STATE OF NORTH CAROLINA
DEPARTMENT OF TRANSPORTATION

SUBJECT: **Request for Modification of the Section 404 Individual Permit, Section 401 Water Quality Certification, Isolated Waters State General Permit, and Neuse River Riparian Buffer Certification** for the proposed East End Connector from NC 147 (Durham Freeway/Buck Dean Expressway) to north of NC 98 (Holloway Street) in Durham, Durham County, North Carolina, Division 5. Federal Aid Project No. NHF-76-1(2), TIP No. U-0071.

The purpose of this letter is to request a modification to the United States Army Corps of Engineers (USACE) Section 404 Individual Permit and North Carolina Division of Water Resources (NCDWR) Section 401 Water Quality Certification, Isolated Waters State General Permit, and Neuse River Riparian Buffer Certification for the above-referenced project.

In addition to this cover letter, please find enclosed revised Wetland Permit Drawing Sheet Nos. 20, 21, 43, 44, 75, 90, and 91 of 91; revised Buffer Permit Drawing Sheet Nos. 5, 9, 10, 17, and 18 of 18; and the revised Mitigation Acceptance Letter from the N.C. Division of Mitigation Services (DMS).

SHEET 91 of 91

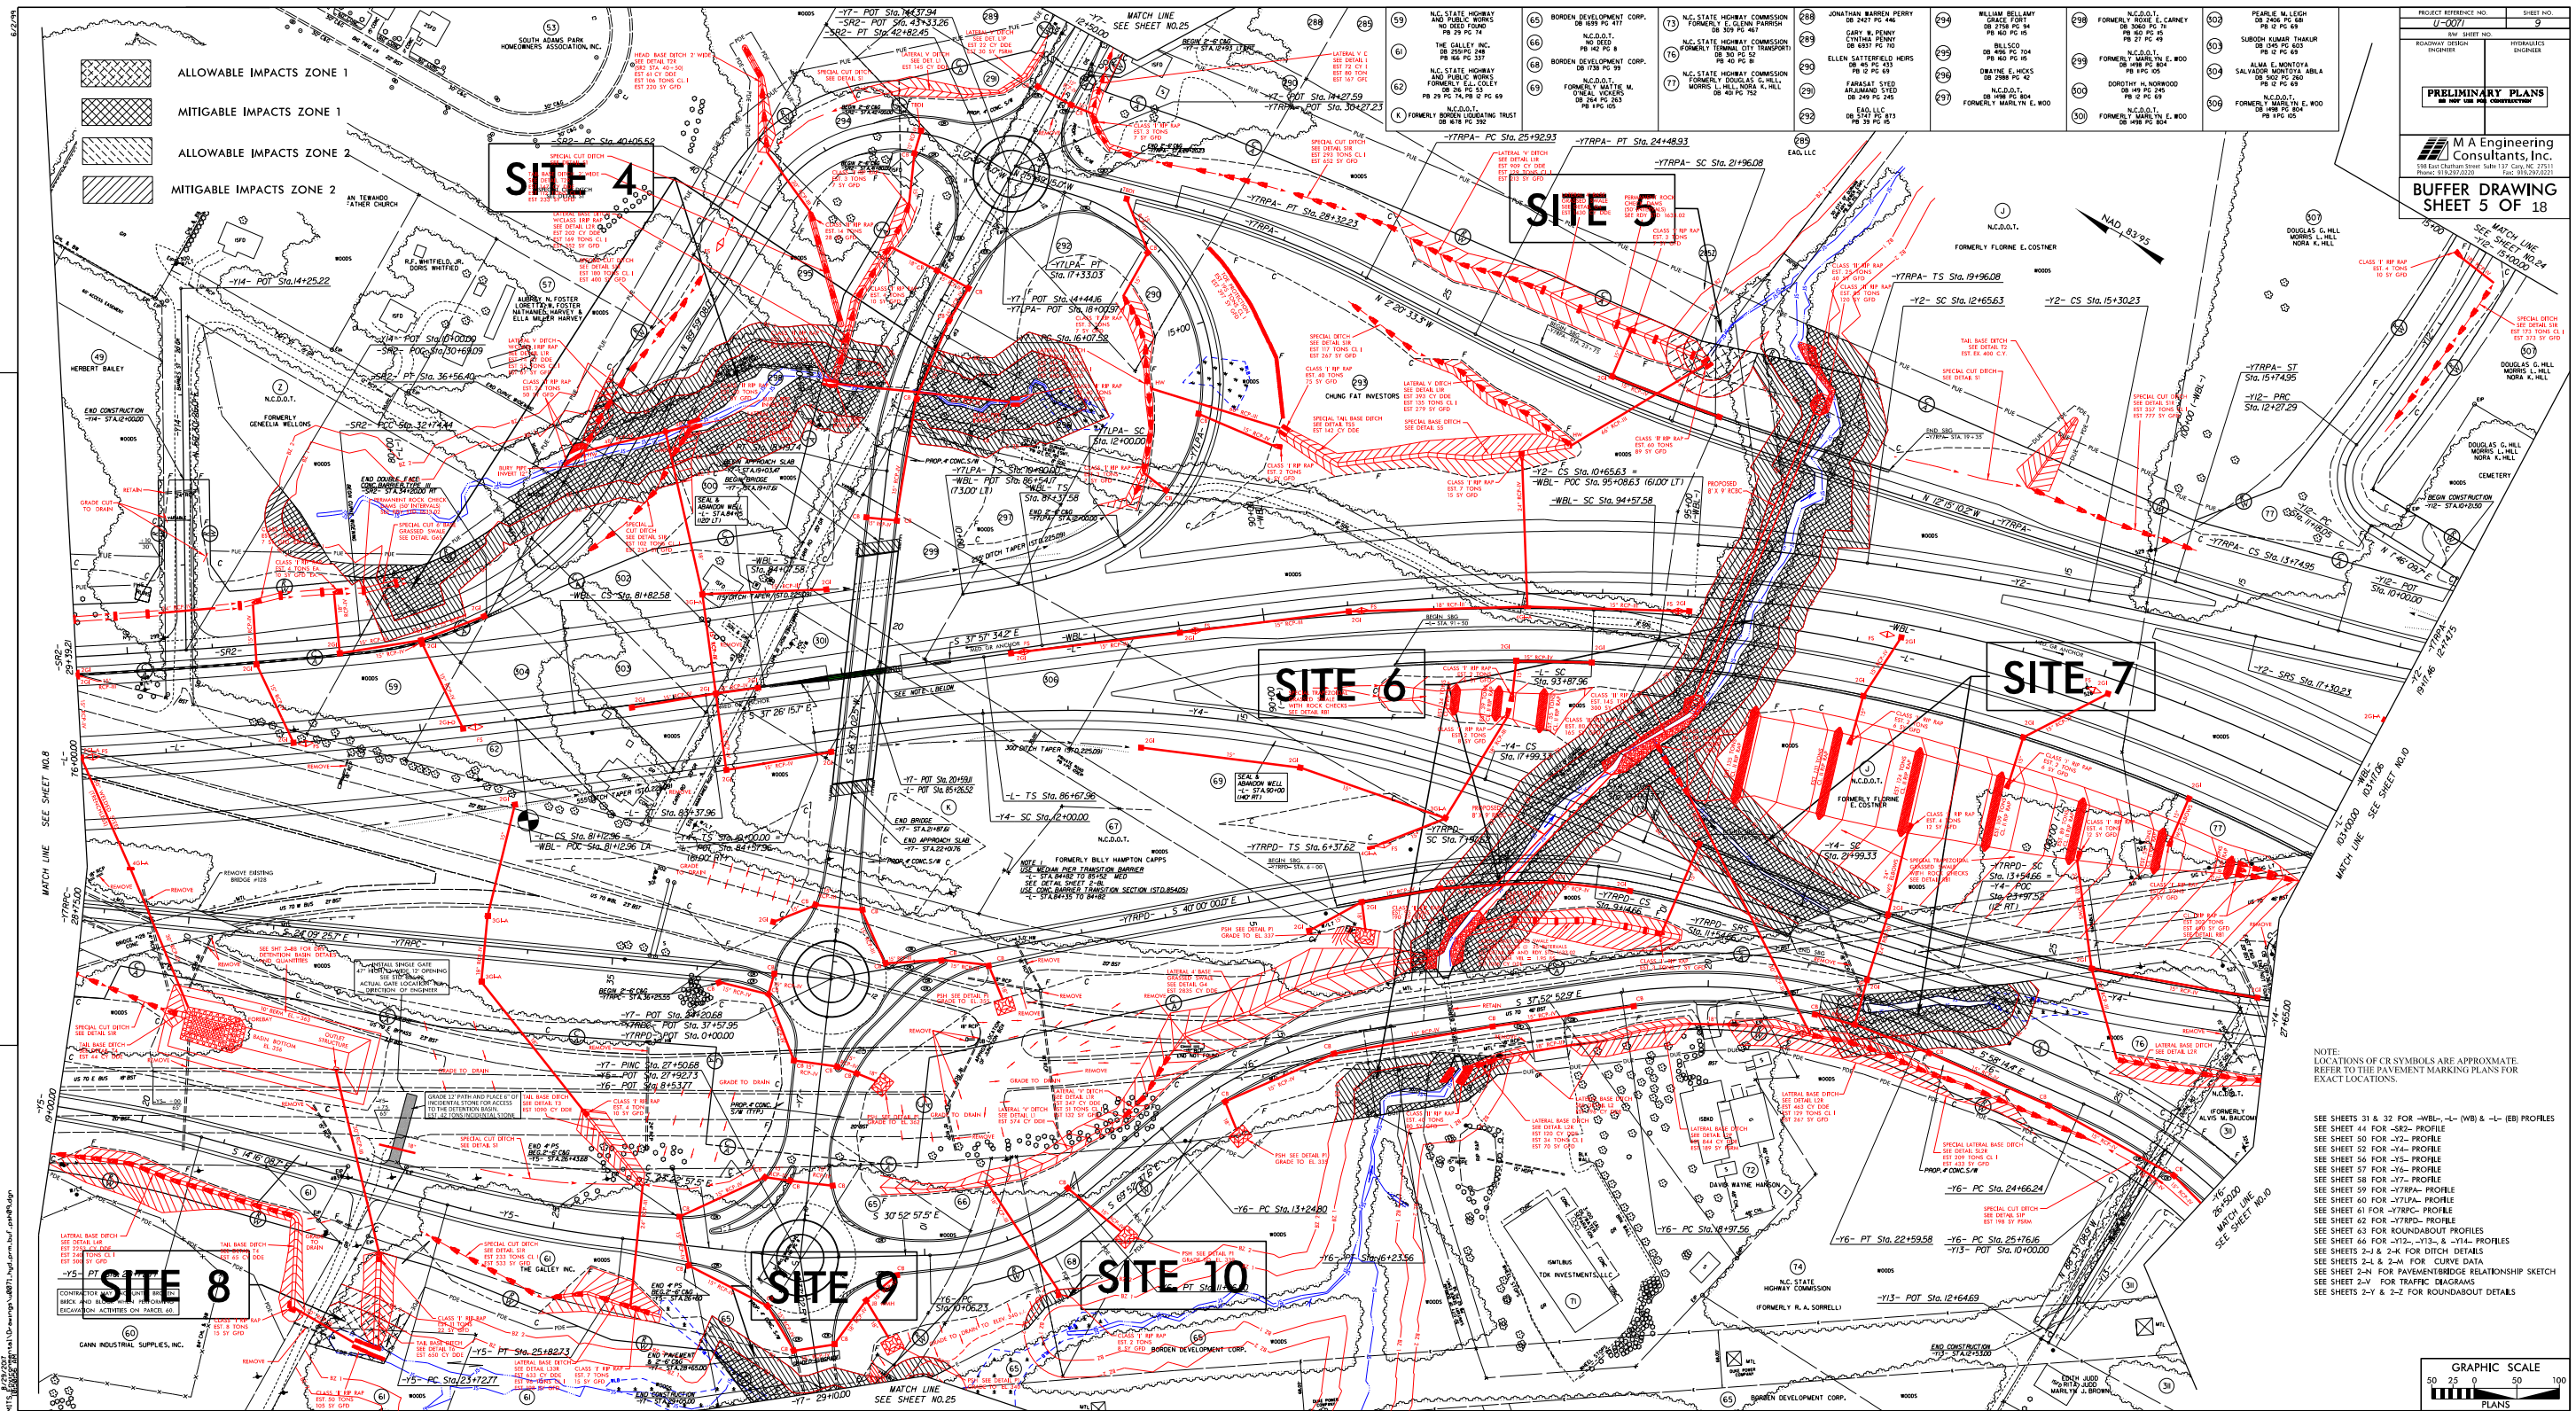
** Site 11 Mechanized Clearing Wetland Impacts have been removed

BUFFER DRAWING
SHEET 9 OF 18

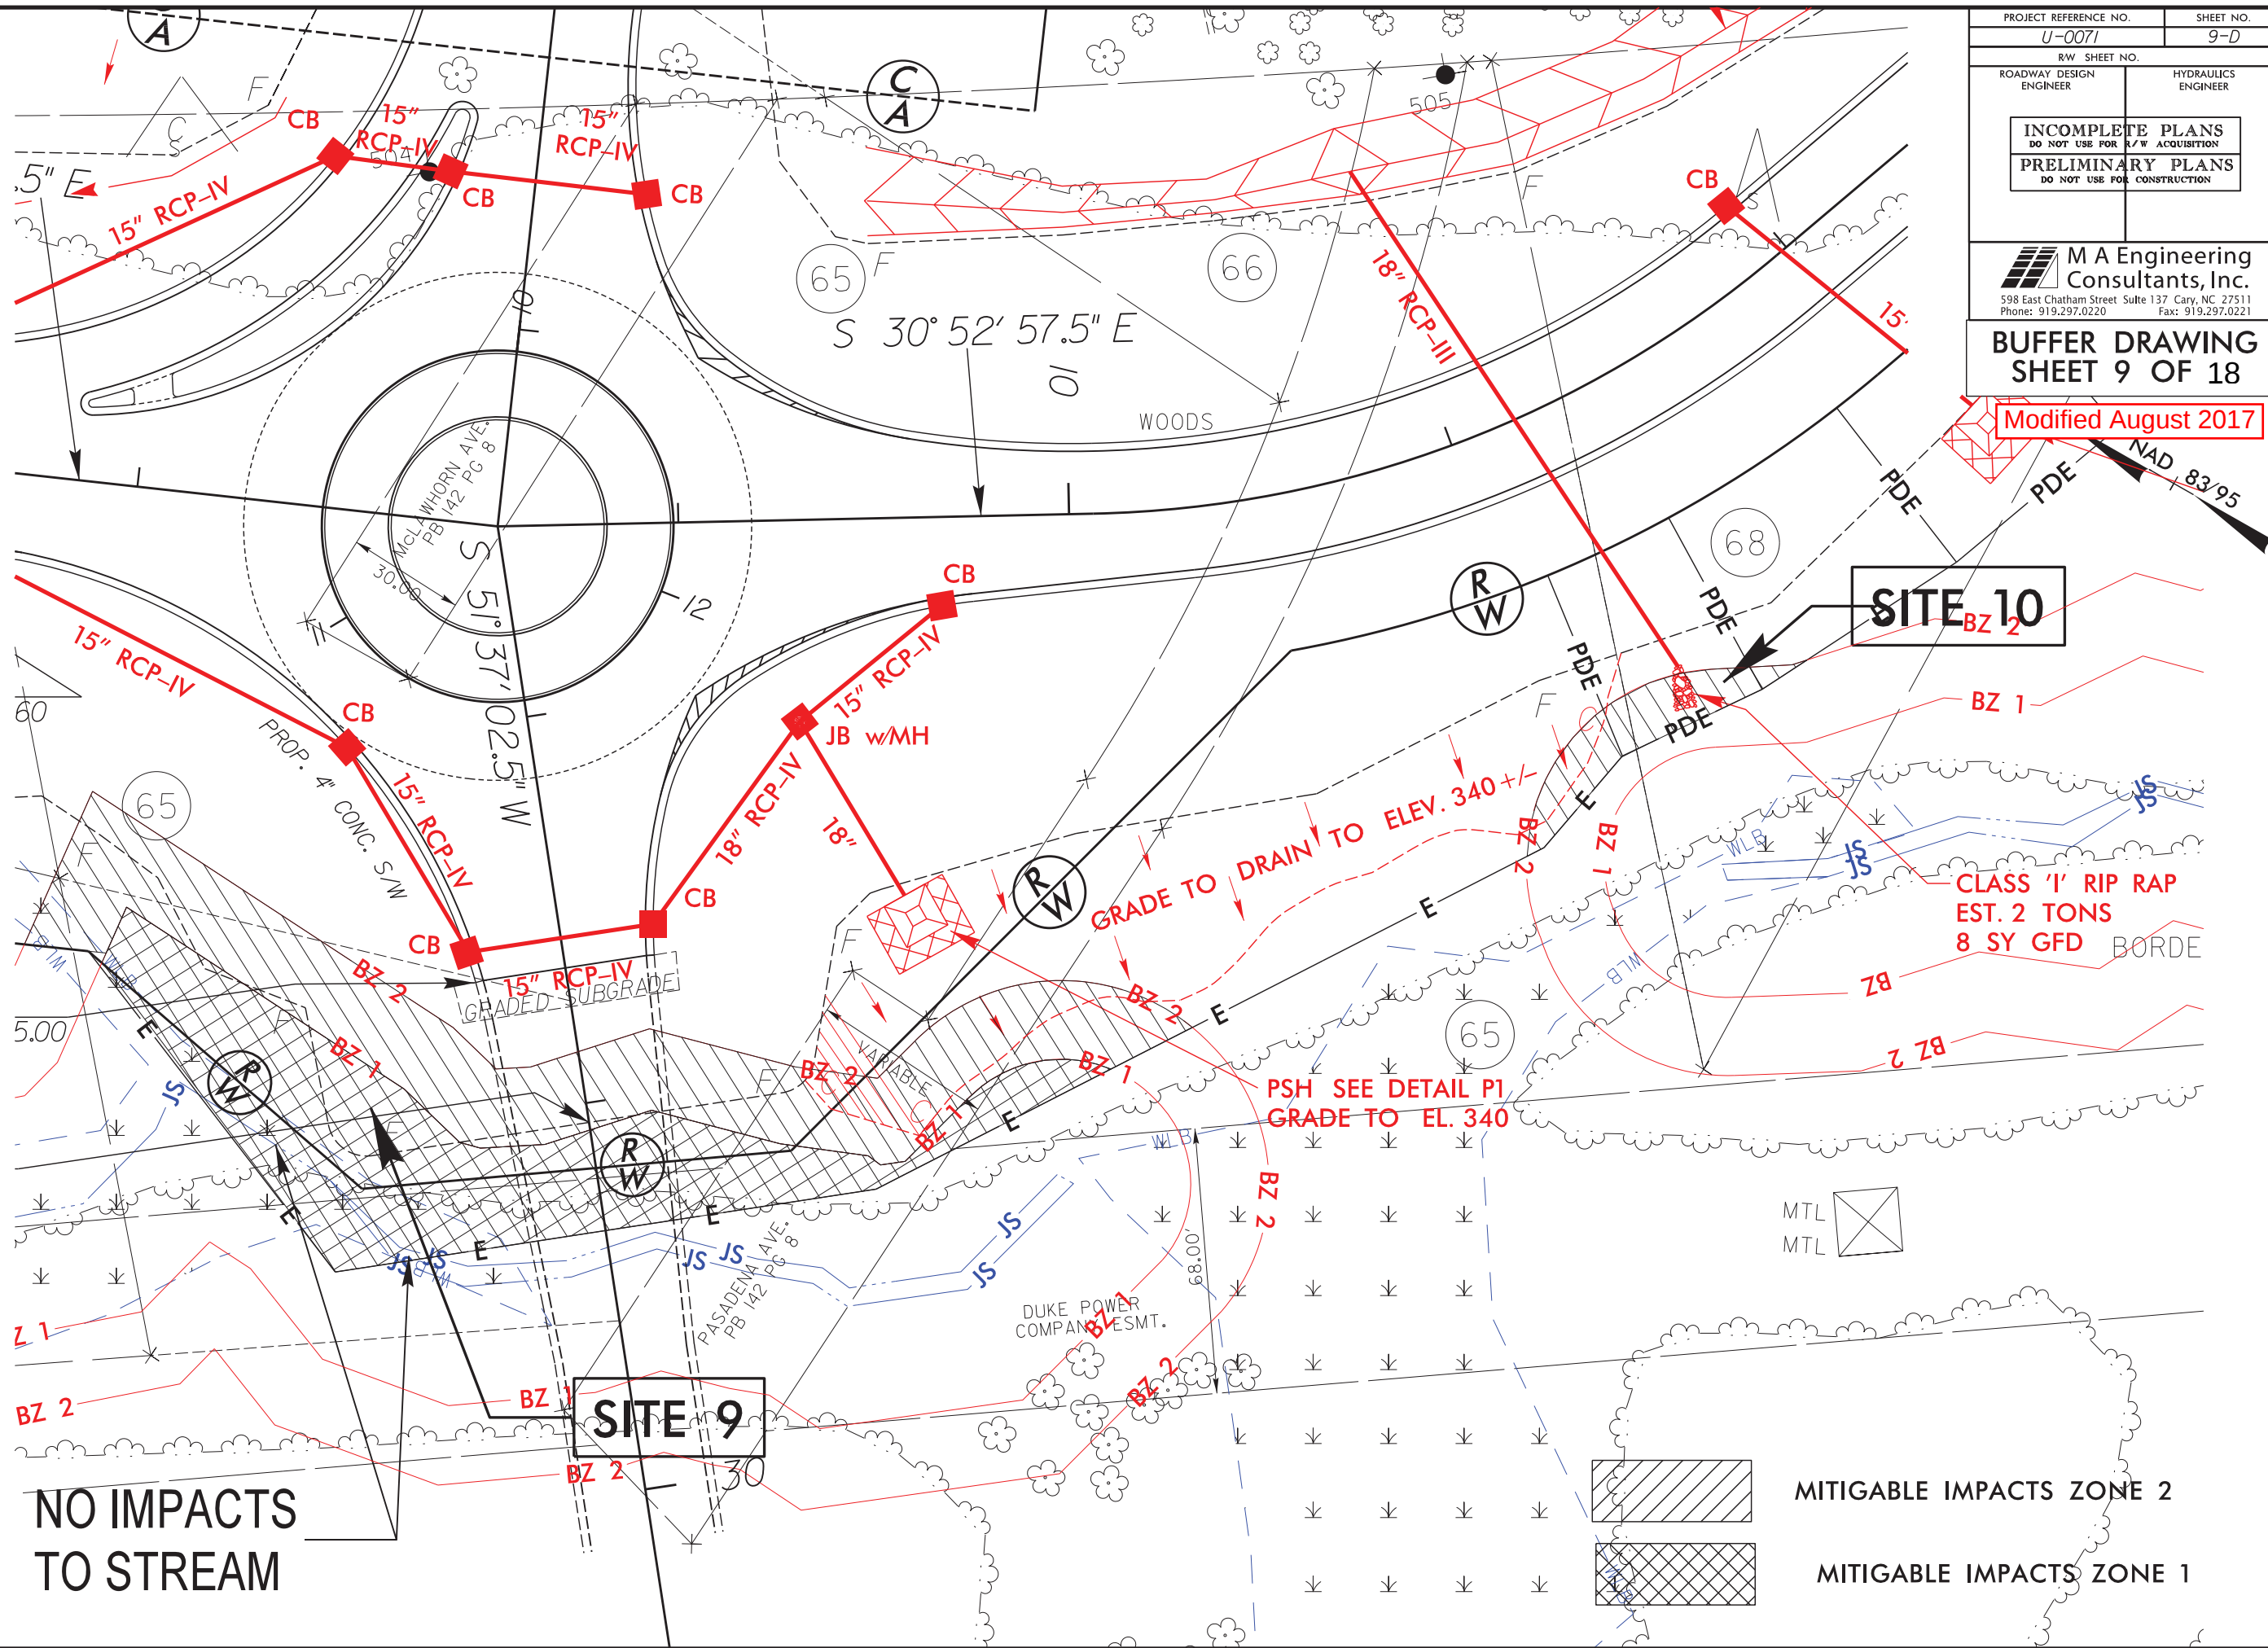
- Due to right-of-way/construction changes, there will be an increase of 2,115 square feet of Zone 1 and 507 square feet of Zone 2 mitigable Impacts Other than Road Crossings (Parallel Impacts) at this site.

- Due to right-of-way/construction changes, there will be a decrease of 977 square feet of Zone 1 and 904 square feet of Zone 2 mitigable Impacts Other than Road Crossings (Parallel Impacts) at this site. This change completely eliminates all Zone 1 impacts at this site.
